MFN 15-069, Supplement 1

GEH's Response to NRC's Request for Supplemental Information to Item #26 – Fukushima Recommendation 4.2 - Mitigation Strategies

ABWR DCD Revision 6 Markups

Figure 2.1.2a NBS Safety/Relief Valves and Steamline

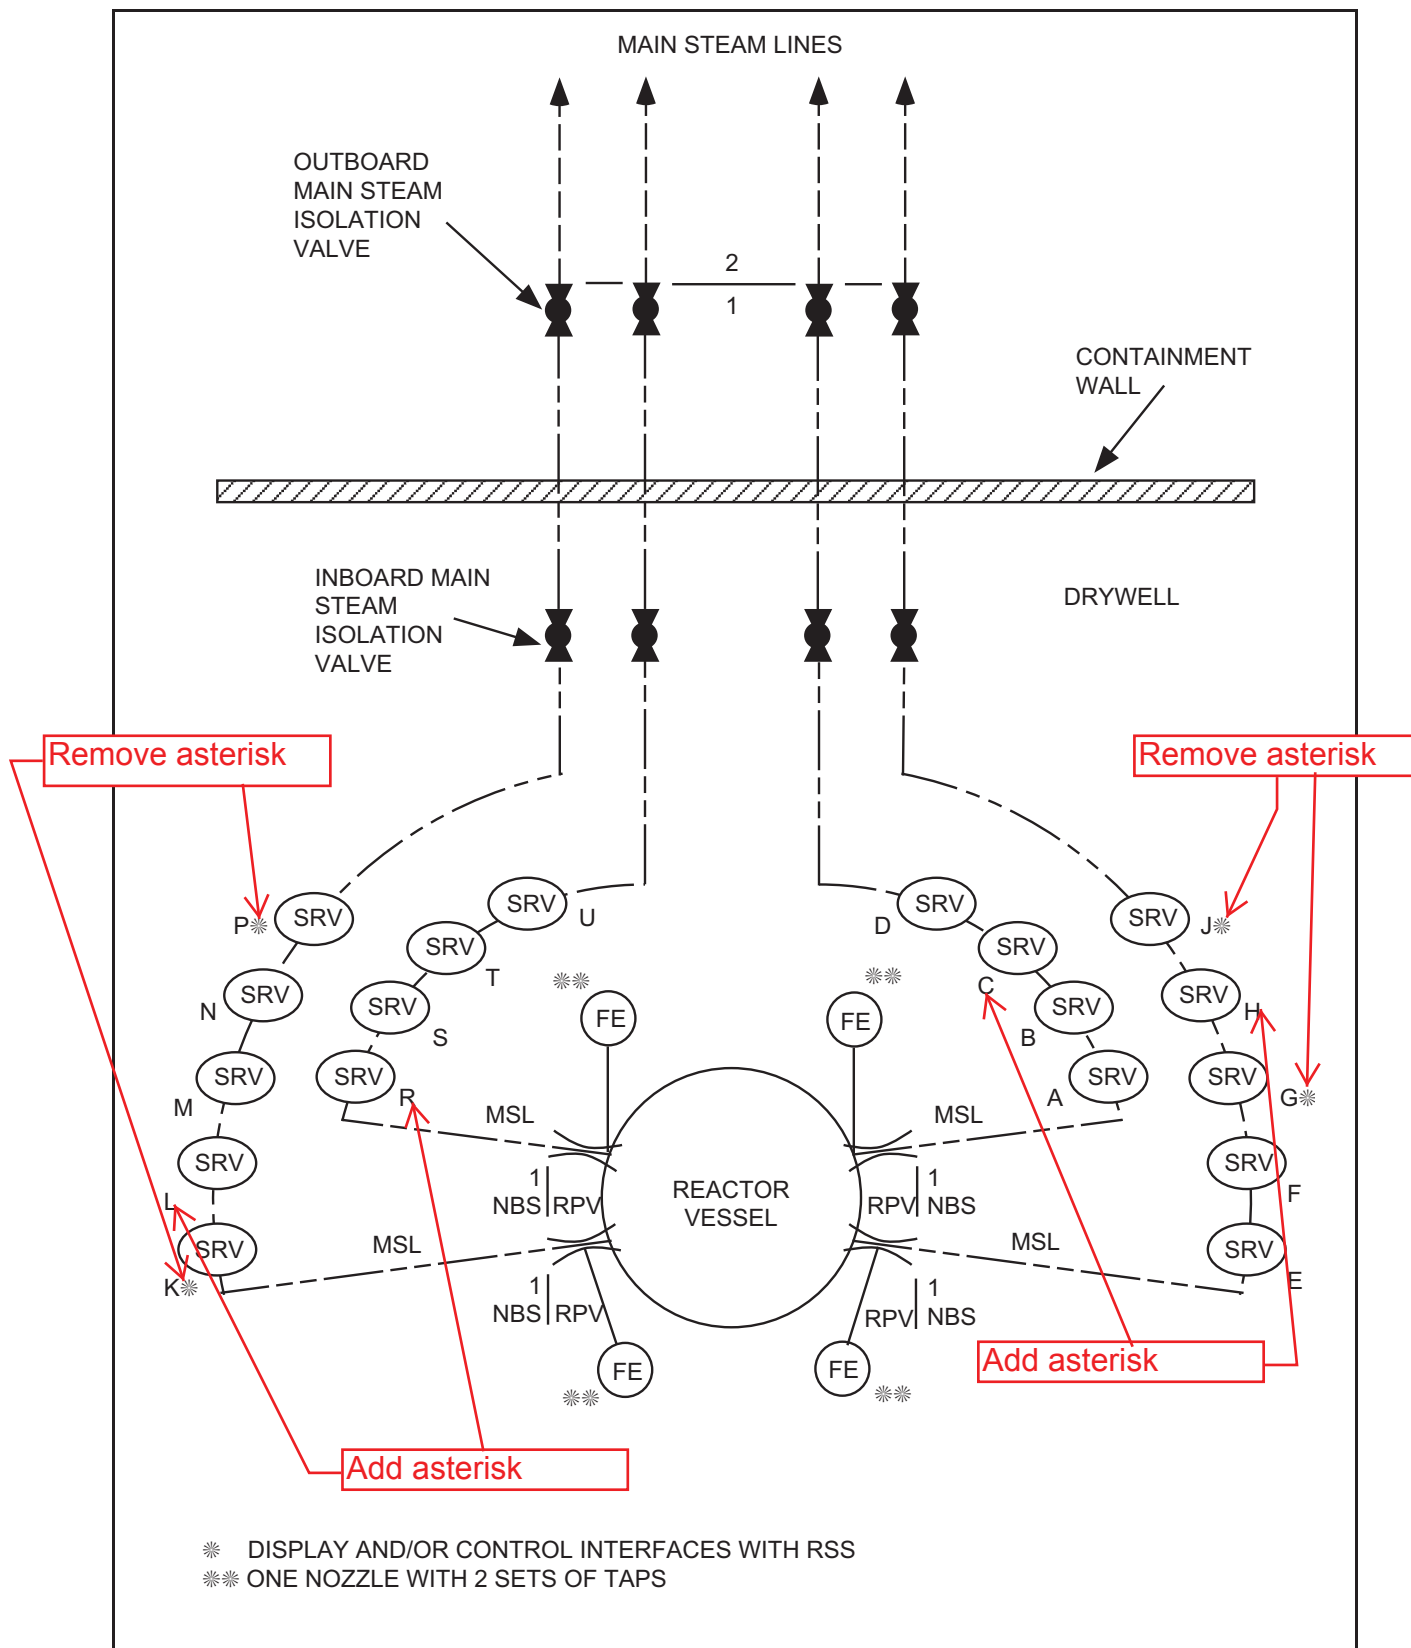
- Added Reactor Building (RB) external connections for FLEX diesel generators to 480VAC RB 1E power centers.
- Replaced control of SRVs G, J, K, and P with Control of ADS SRVs C, H, L and R on the Remote Shutdown Panel (RSP)

Figure 2.2.6 Remote Shutdown System

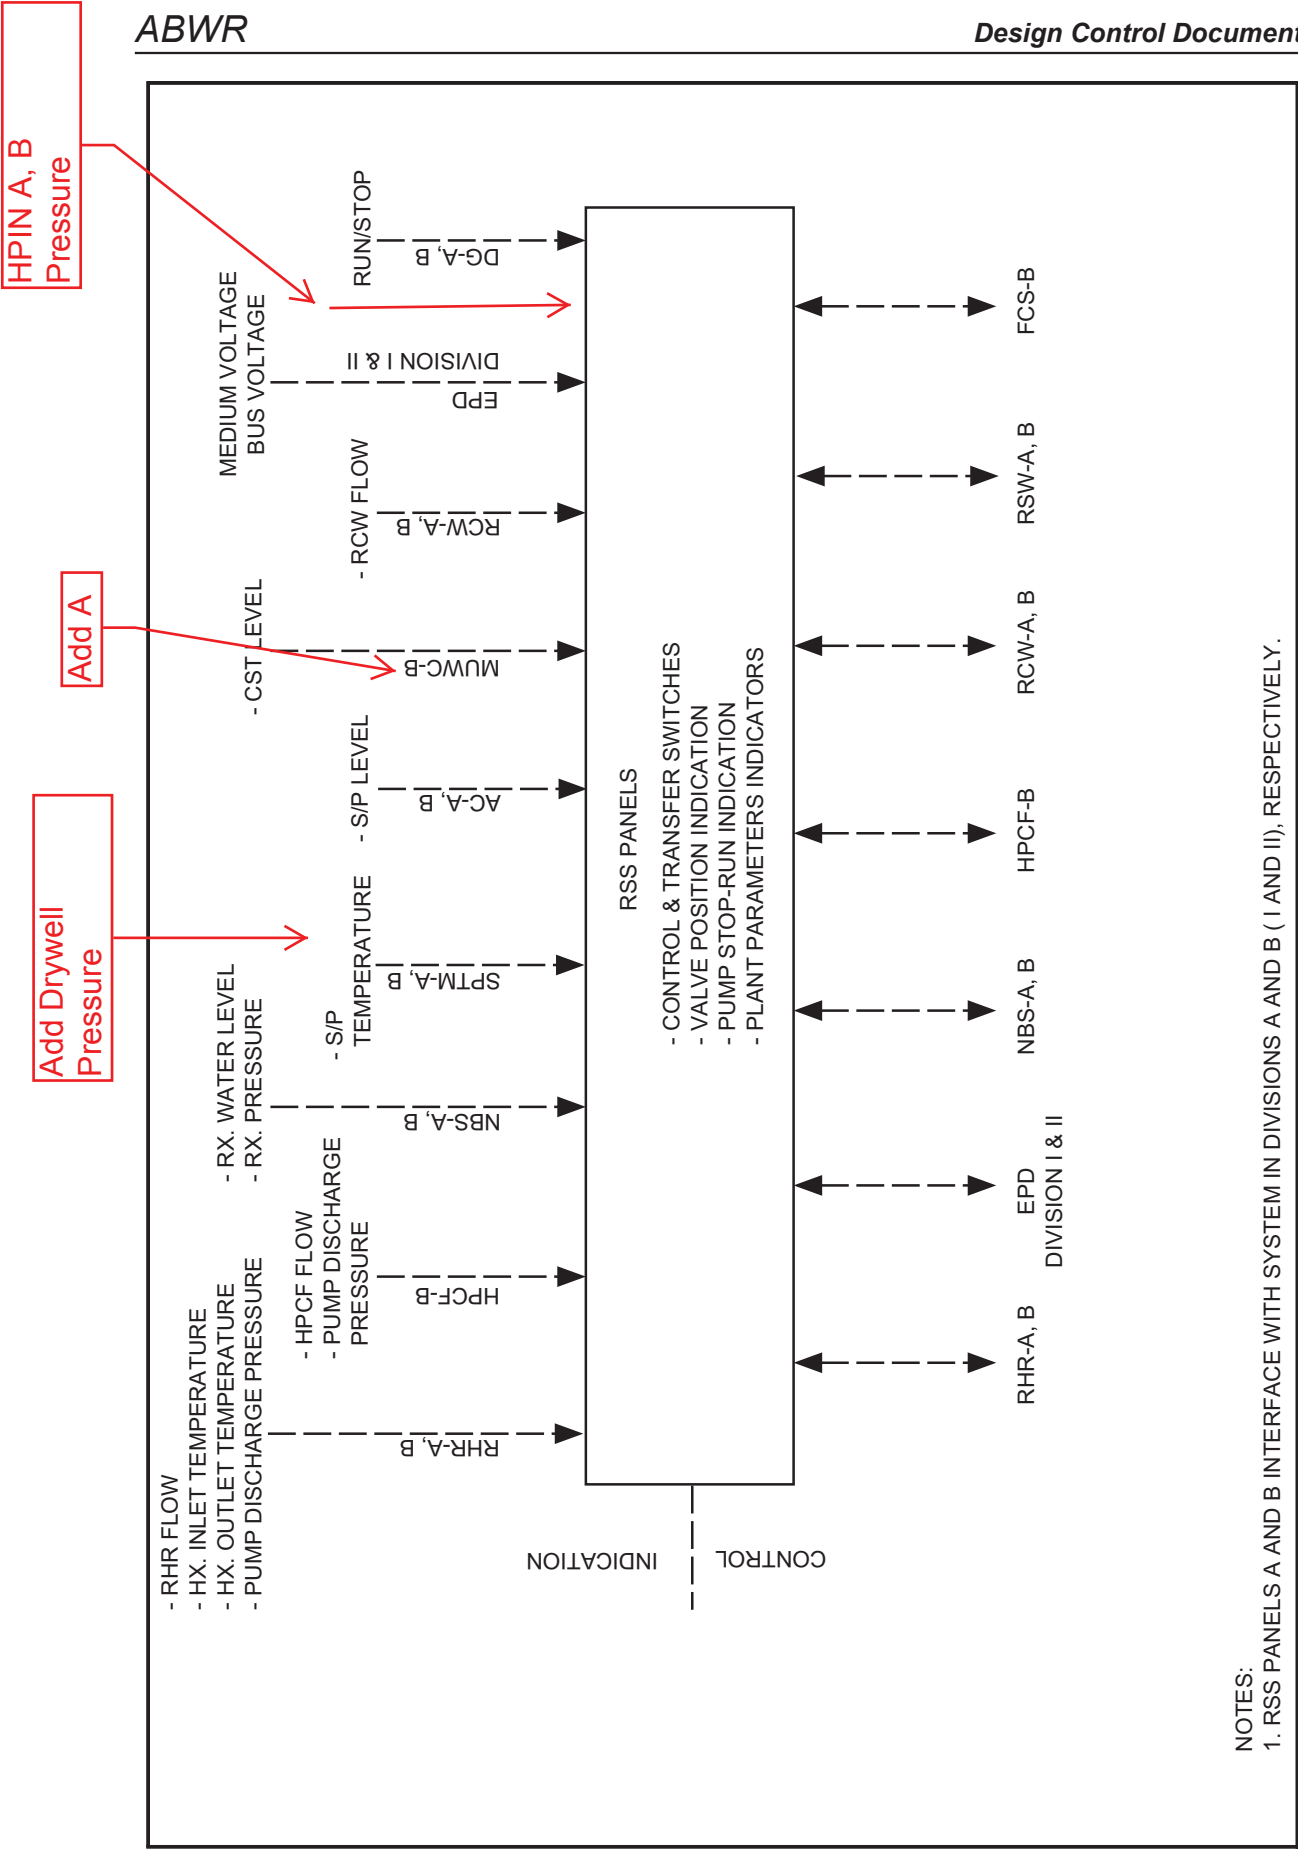
(12) High Pressure
Nitrogen Gas
Supply System

Figure 7.3-2 Nuclear Boiler System IBD (Sheet 2 of 37)

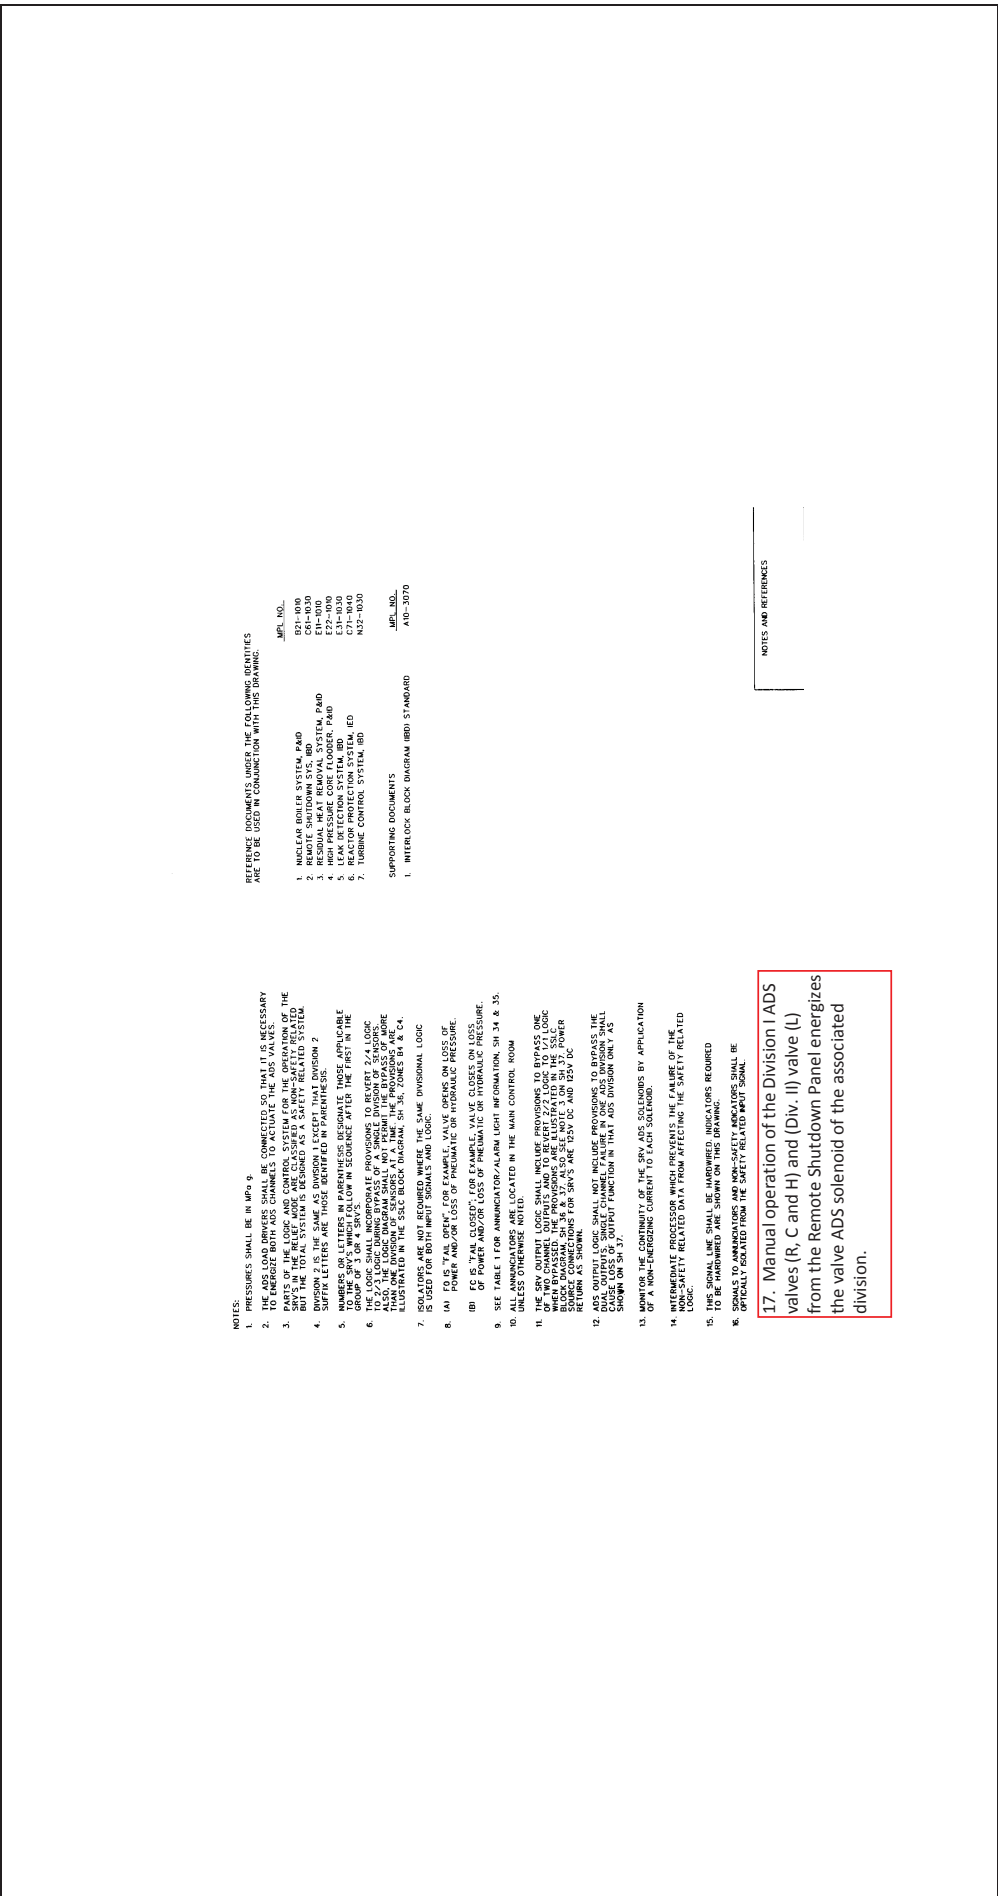
17. Manual operation of the Division I ADS valves (R, C and H) and (Div. II) valve (L) from the Remote Shutdown Panel energizes the valve ADS solenoid of the associated division.
